Transdev Services, Inc. Addendum No. 1 IFB NO.V-2523 CUTAWAY BUS

Date 8/1/2025

IFB NO.V-2523 CUTAWAY BUS

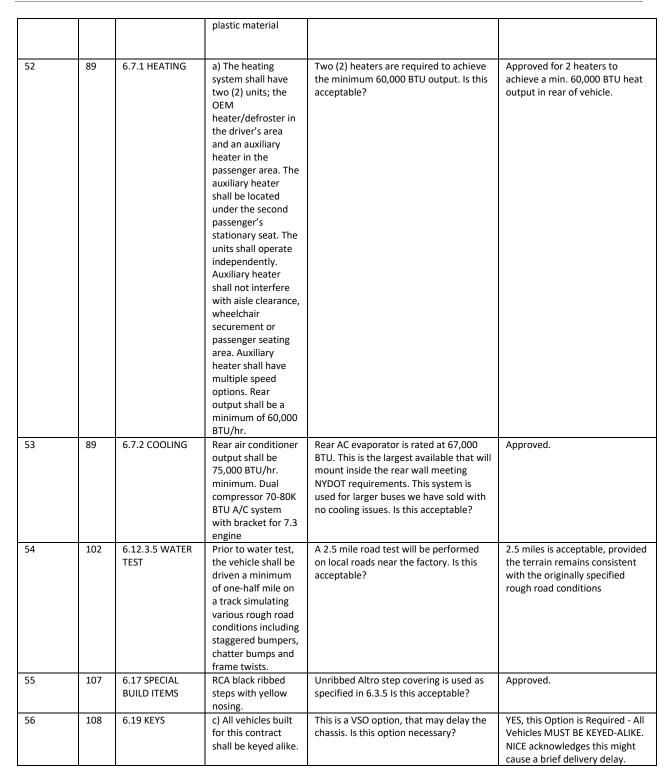
30	72	6.3.2 BODY STRUCTURE	c) Roof interior shall be fiberglass, vinyl sheeting or equal material.	The ceiling is made with 22 gauge prepainted aluminum panels. Is this acceptable?	This is Acceptable as long as the ceiling shall be primed on both sides.
31	72	6.3.4 CORROSION RESISTANCE	c) NICE Bus requires a low gloss, fast dry, red-oxide, solvent based polymeric rust preventative coating.	The entire underside of vehicle is undercoated once assembly is complete, using an asphalt based Tectyl coating from Corrosion Control. Is this acceptable?	Approved.
32	72	6.3.5 FLOOR	a) The floor structure shall be constructed of High-Strength Low- Alloy steel with a minimum Yield Strength of 50,000 psi and a Tensile Strength of 60,000 psi.	The yield strength of 45,000 psi. Is this acceptable?	Acceptable
33	72	6.3.5 FLOOR	The steel floor structure shall be primed and painted before being mounted on the chassis.	The steel floor is not painted or primed. The top side has rust proof sound deadener applied and the underside has an asphalt based undercoating. See the attached details of our floor construction. Is this acceptable?	Approved
